HARTING Product Change Notification

PCN/18/014/C+N

Title: D-Sub hoods with straight cable entry and screw locking - External

(Image shows the 9-pole plastic hood and is for illustration purpose only)

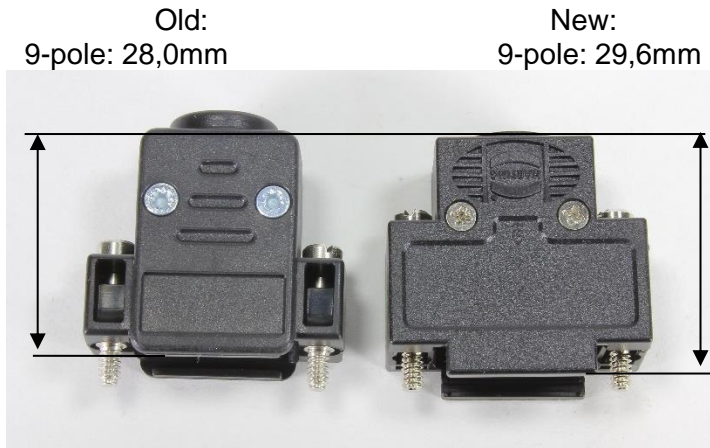
- Locking screw preassembly

Old: locking screw preassembled
in the cover

New: locking screw preassembled
in the hood
